ICC A117.1 Comments on 2nd Draft

Proposal list to the 2017 A117.1 for the 2023 edition –
03-30-2025
Chapter 7 to 11

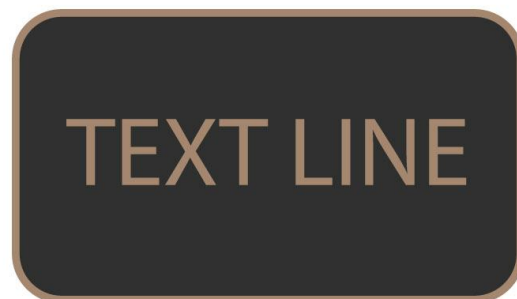
The Weber formula can optimize contrast for people having low vision, as well as people who have reduced contrast sensitivity only if it is qualified by a minimum LRV for the lighter surface. The following figures show how the Weber contrast (without qualification) can readily be 65% or greater when signs are comprised of two relatively dark colors, and not appear to the human eye as having high contrast. Black Magic on Green Herb, and Iced Mocha on Black Magic both contrast by more than 80%, well above the required 65%. Nonetheless, they are not perceived as having high contrast.

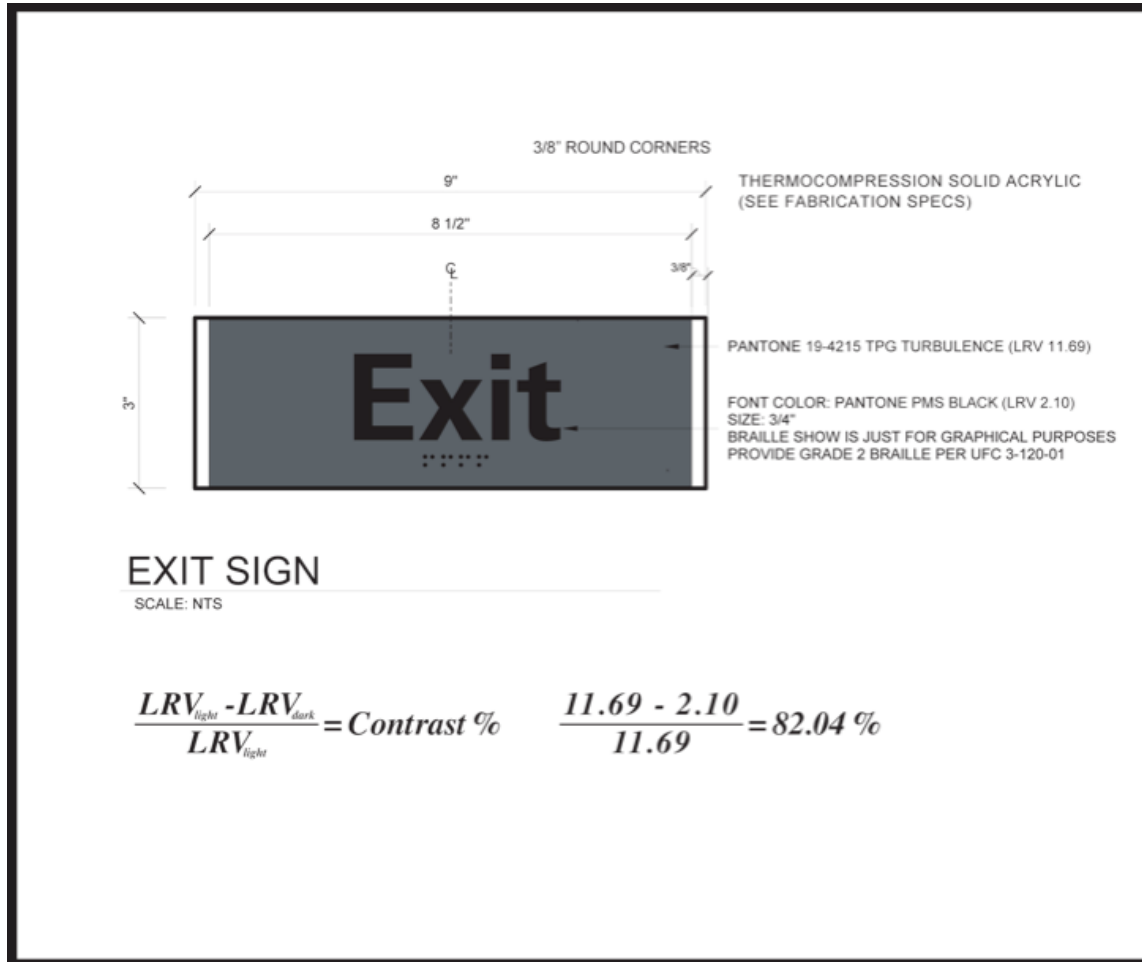
Here is another example of sign specifications, in which the LRV of the gray lighter color is 11.69, and the LVR of the black is 2.10. The resulting (Weber) contrast is 82.4%, far greater than the 65%; nonetheless the sign is not highly legible. Ironically, the designer is requesting exit signs, whose legibility may often be reduced by smoke, that are minimally legible.

Without qualifying the (Weber) contrast requirement of 65%, we are making it very simple for designers and manufacturers to design and manufacture signs that are minimally legible. We have not succeeded in creating a standard that will consistently result in signs that are legible to people with low vision, or to people with reduced contrast sensitivity. We have simply made it easy for designers and manufacturers whose products might have been disapproved by inspectors, based on their own perception, using the unquantified, hence unmeasurable, “light on dark or dark on light,” to state that signs that are minimally legible have high numeric contrast and pass a requirement for 65% contrast.

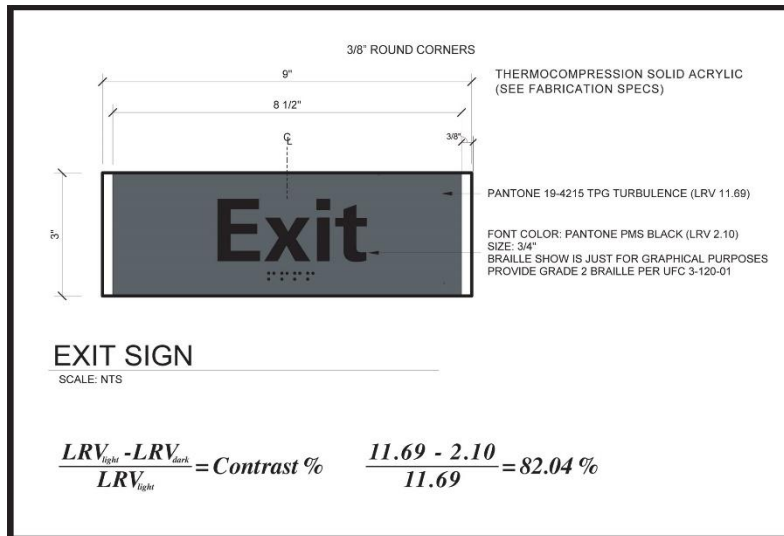
The ISA website snippet below says “While most designers will use a combination of a very dark color with a very light color, there are some colors that could be “light” or “dark”, depending on the other color selected.” It goes on to show that the color “Green Herb” (LRV 27.8) can be either a light color or a dark color, depending on what color it is paired with. The page concludes with the following “Note: Most colors can be used only as dark or only as light, not both.”
